AGENDA
HISTORIC PRESERVATION BOARD
City Commission Chambers
August 24, 2023 8:30 A.M.

AGENDA
DESIGN REVIEW COMMITTEE
August 24, 2023

**HISTORIC PRESERVATION BOARD
DESIGN REVIEW COMMITTEE
STAFF REPORT
August 24, 2023**

**HISTORIC PRESERVATION BOARD
DESIGN REVIEW COMMITTEE
STAFF REPORT
August 24, 2023**

FOR PORCH ADDITION TO AN EXISTING HOME
FOR: NORMAN ALTMANO
915 EAST LIME ST. LAKELAND, FL 33801

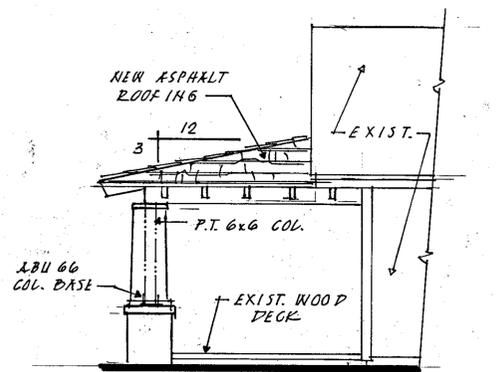
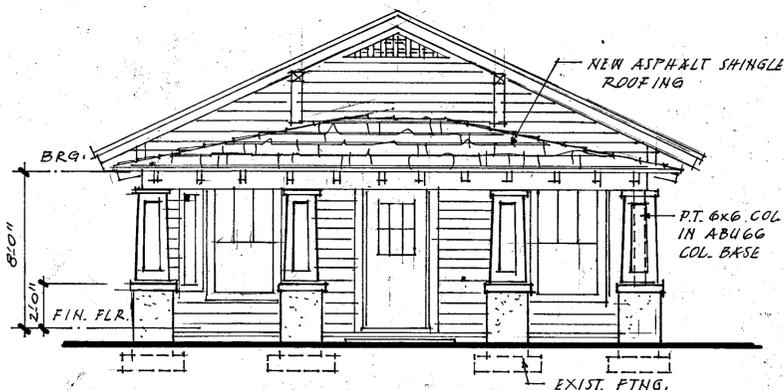
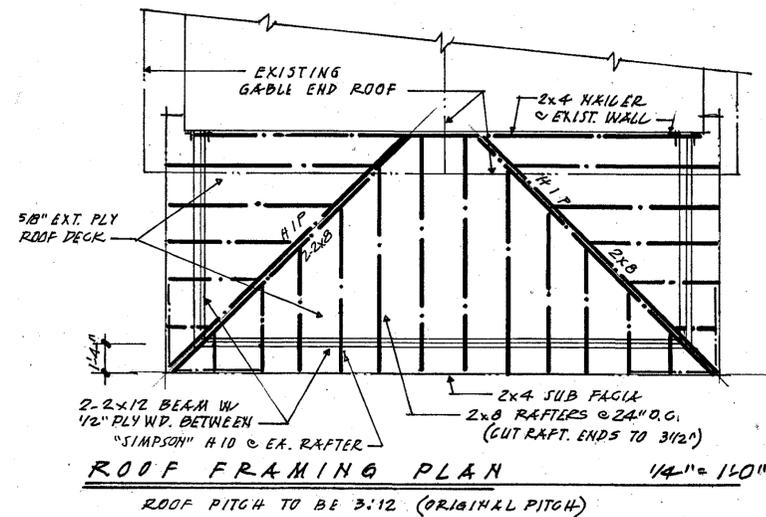
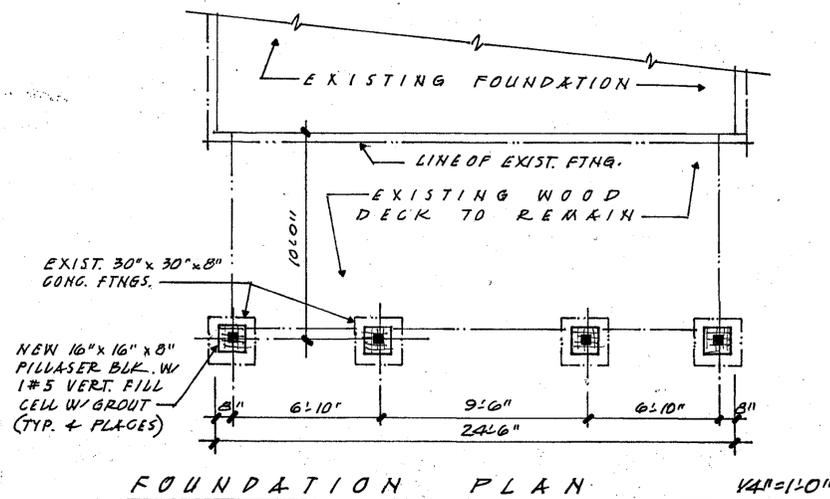
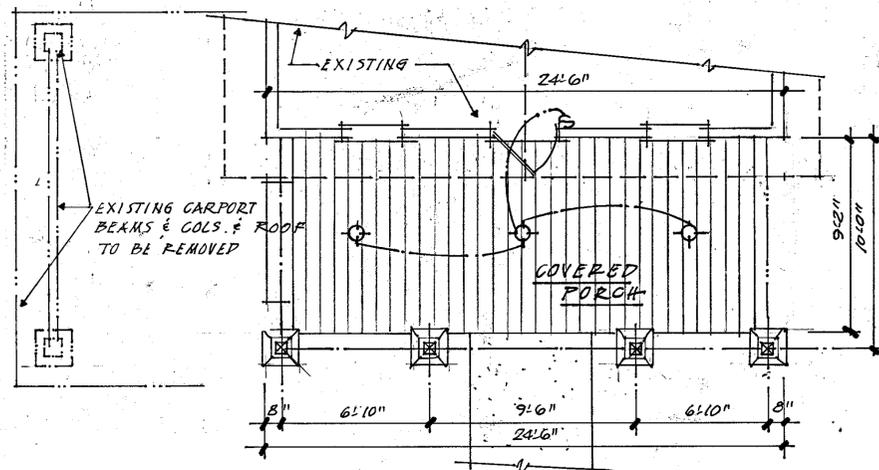
Earlier this year, the front porch and porte cochere was destroyed by the impact of a vehicle collision. Subsequently, the remaining front porch and porte cochere was demolished and in-kind repairs to the front of the house were made to protect the house and allow the tenants to safely enter. The Applicant proposes to reconstruct the front porch only, replicating the 3/12 pitch hipped roof with exposed rafter tails, tapered columns using Hardie materials, and pilaster block plinths to be finished with painted stucco. The integrated porte cochere is not proposed to be reconstructed. Traditional frame construction methods will be used to reconstruct the front porch.

Staff finds that the request proposes a sensitive reconstruction of the front porch using appropriate replacement materials and a design similar to the destroyed porch, which is consistent with the Design Guidelines and Standards. As the original porte cochere was integrated into the hipped roof structure of the front porch, as well as featured two columns in the same design as the columns of the front porch, the porte cochere should also be rebuilt with the same design and dimension that historically existed. Both the front porch and porte cochere are features that define the Craftsman Bungalow architectural style of the subject house and should be rebuilt to retain its architectural and historic integrity.

Approval of the request with the condition that the porte cochere also be rebuilt in the same design and dimension that historically existed.
